Subject:	Wekiya River Crossing - Two Bridge vs. Three Bridge Analysis
CC:	Hannah Hernandez (FDOT), Robert Robertson (FDOT), Linda Figg (Figg), Tom Roberts (E-Sciences), Lloyd Gurr (GAI)
From:	Steve Boylan (GAI)
То:	Kevin Moss, FDOT Project Manager
Project No.:	Wekiva Parkway Section 6 FPID 238275-7
Date:	February 7, 2014

Subject: Wekiva River Crossing - Two Bridge vs. Three Bridge Analysis

TWO BRIDGE ALTERNATE

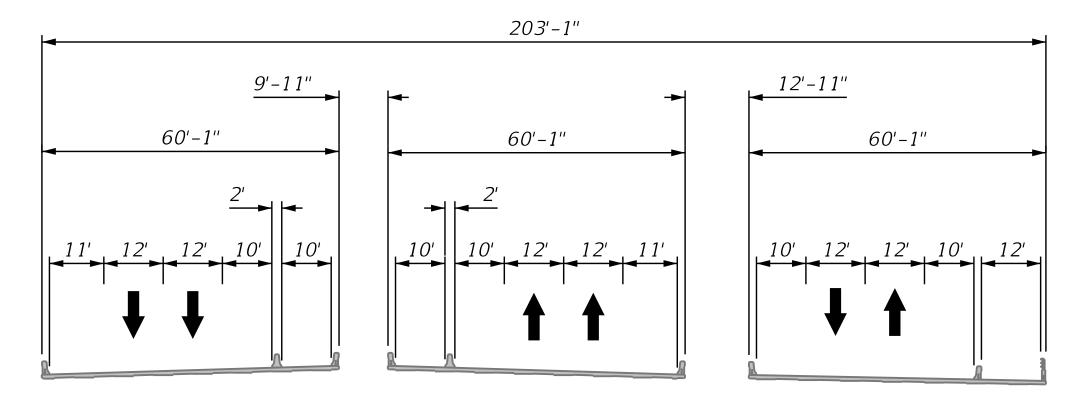
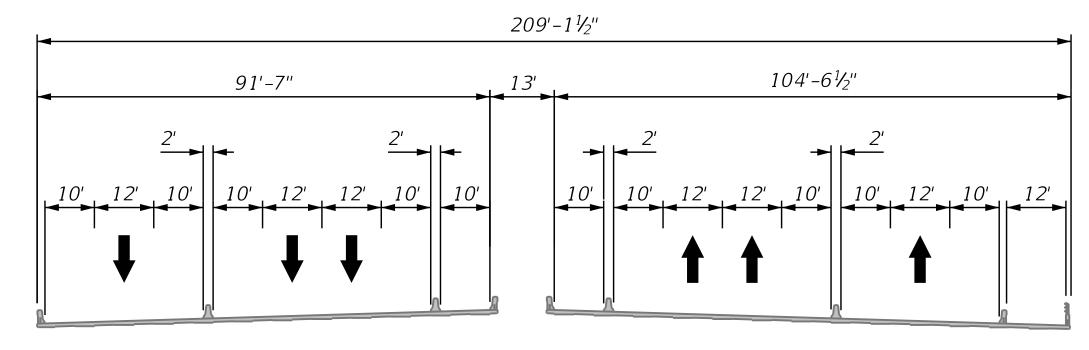
As shown in the attached exhibit, consolidating the service roadway and parkway onto two structures provides virtually no benefit:

- Total width of bridge envelope is 6' greater than established three bridge alternative;
- Only one 13' light "portal" provided in two bridge option;
- Increases island overhang from established three bridge alternative;
- Additional bridge does not allow for future mainline capacity (different profile);
- Change to project configuration could add significant delays to the project as a result of re-evaluation by FHWA.

For these reasons, we recommend keeping the originally proposed three-bridge section as previously approved by the Department, stakeholders, and FHWA.
